PREVOST

**SAFETY
RECALL**

SR22-05A

DATE :	September 2022	SECTION :	06 ELECTRICAL
SUBJECT:	ALTERNATOR BELTS REPLACEMENT

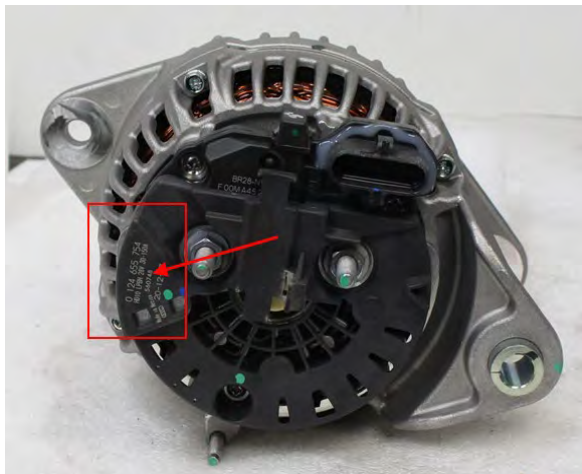
1. On vehicle equipped with a mechanical cooling fan, remove the fan belt.
2. Remove the left hand alternator belt (if so equipped)
3. Remove both AC V-belts (manual tensioner)

- Slack the manual adjustment screw.
 - Remove the tensioner.
 - Remove the belts.
4. Remove the water pump belt.
 5. Remove the right hand alternator(s) belt.
 6. Spin all alternators and make sure no bearing noises are coming from the alternator(s). Replace alternator(s) as needed (Only OEM alternator(s) with noisy bearings are covered by this safety recall; See *OEM Alternator Identification* below).

As a good practice, spin all idlers and tensioners and make sure no bearing noises are heard and replace the bearing(s) as required (idler & tensioner *are not* part of this safety recall unless covered by std vehicle warranty – Std warranty process must be used to claim these parts).

7. Reverse the procedure to reinstall the belts on the vehicle.

BOSCH HD10

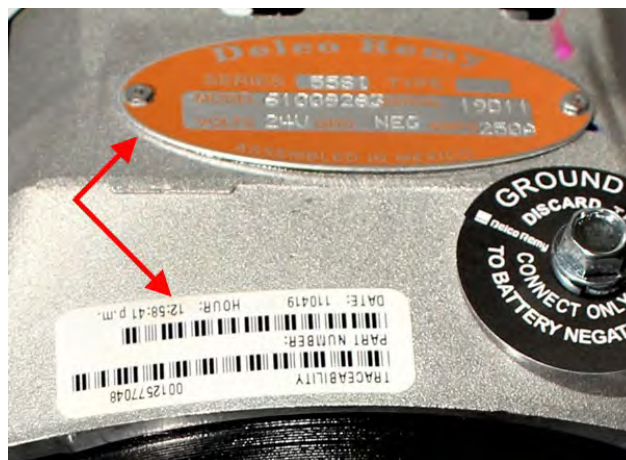
- BOSCH HD10 OEM alternator will have a Prevest part number stamped on the back cover (as well as Bosch part numbers).
- These identification marks (numbers) can either be printed in white or stamped/molded in the plastic cover (150amp HD10 with white marking shown).
